# **Appendix C**

## Comments from Cedar Environmental, Charles Judd, President

September 21, 2007

Dane Finerfrock, Director
Division of Radiation Control
168 North 1950 West
P.O. Box 144810
Salt Lake City, Utah 84114-4810

FIGURE A

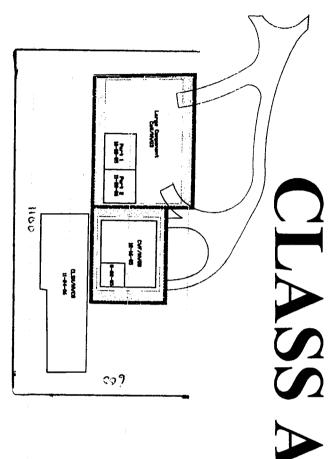
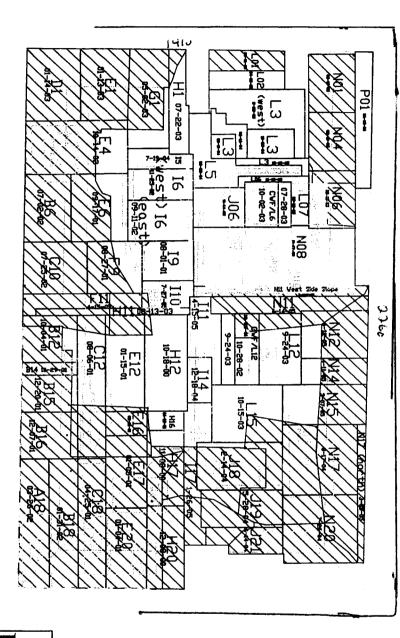
For the 2007 review it is important to calculate all of the steps necessary to close the site anytime up until August 2008. The first thing to calculate is the type of cell that would need to be constructed to close the site properly. As License Condition limits the open cell area within the Class A and Class A North disposal embankments where the waste disposal/placement has <u>or may</u> occur. Looking at this requirement and Figure A which is Energy*Solutions* area of temporary cover you can see the areas that have been opened for placement of waste or areas where waste placement may occur. The yellow line shows the limits of where waste would need to be placed to close the facility.

This is at least how big the footprint must be if you consider the following: 1) You need to keep at least 300,000 cubic yards space for site cleanup (much more for proper placement of debris: see other comments about the 1:1 ratio change); a better estimate would 500,000 so that there is more soil with debris 2) between now and august 2008 you could receive up to 300,000 cubic yards of waste3) you need 100,000 cubic yards for wastes that are in storage, 4) debris cannot be placed in the top foot or bottom foot (this depth is way to small when you consider that the embankment could settle 4 feet; see other comments) 5) debris should not be place in the top half of any embankment (see other comments), 6) large components and cwf should be placed in bottom lifts, 7) there is limited amount of space in the Class A cell: less than 700,000 cubic yards as of today.

You must also consider that it is not possible to build a final cell that has concave edges. The final cell will need to be square or rectangle. Odd corners would create issues with runoff from the top of the cell. The cell may even have to be bigger than what is suggested here, but using these numbers the cover space needed would need to be

Class A 2260 x 1410 = 3,186,600 s.f.

Class A North  $1100 \times 600 = 660,000 \text{ s.f.}$

Total Open Now 3,846,600 s.f.

To be conservative it would be best to use at least 4,000,000 square feet of cover system for the waste itself and then add more quantities for the ditches and other perimeter features.
